# Access Compliance Report

## Public Rights-of-Way

### (Curb Ramps)

Intersection ID: 19674	Main Street: BARCLAY_DOWNS_DR	Cross Street: MORRISON_BV	Location: NW
ADA ID: 8F2C6D96E746	Ramp Type: Perpendicular Diagonal	Initial Pass/Fail: Fail	Overall Compliance: No
			Severity Score: 21.25

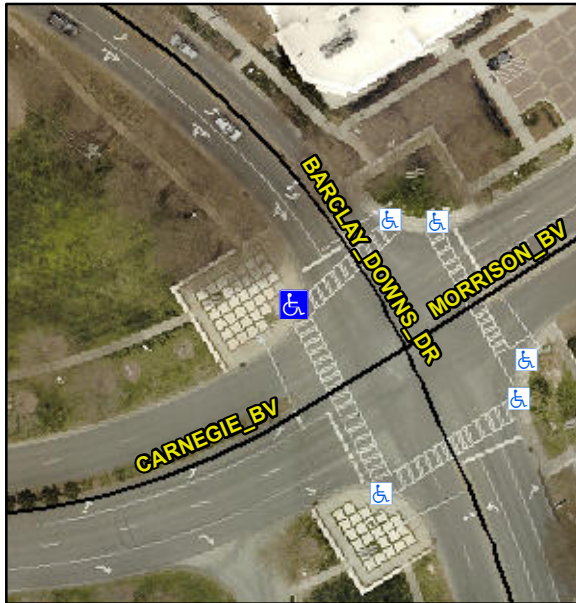
**Not Found, R304.5.1, R304.2.2**

Compliance	Description	Data	Compliance	Description	Data
N/A	Ramp Length (in)	72.0	No	Ramp Slope (%)	8.6
No	Ramp Width (in)	47.0	Yes	Ramp XSlope (%)	1.2
N/A	Flare Type LT	N/A	N/A	Flare Type RT	N/A
N/A	Flare Slope LT (%)	N/A	N/A	Flare Slope RT (%)	N/A
N/A	Flare Traversable LT?	N/A	N/A	Flare Traversable RT?	N/A
N/A	Landing Length (in)	N/A	N/A	DWS Provided?	N/A
N/A	Landing Width (in)	N/A	N/A	DWS Contrast?	N/A
N/A	Landing Slope (%)	N/A	N/A	DWS Length (in)	N/A
N/A	Landing X Slope (%)	N/A	N/A	DWS Full Width?	N/A
N/A	Landing Curb? (Y/N)	N/A	N/A	DWS Offset (in)	N/A
N/A	Shared Landing?	N/A			
N/A	Gutter Ponding?	N/A	N/A	Gutter Slope (%)	N/A
N/A	Gutter Lip Ht (in)	N/A	N/A	Gutter X Slope (%)	N/A
N/A	Painted X Walk1?	Yes	N/A	Painted X Walk2?	Yes
	X Walk 1 Direction	To SE		X Walk 2 Direction	To NE
N/A	X Walk 1 Width (in)	112.0	N/A	X Walk 2 Width (in)	106.0
	X Walk 1 Slope (%)	3.2		X Walk 2 Slope (%)	0.0
	X Walk 1 X Slope (%)	1.3		X Walk 2 X Slope (%)	0.2

**Remove & Replace Curb Ramp With Two New Directional Ramps or Equivalent.**
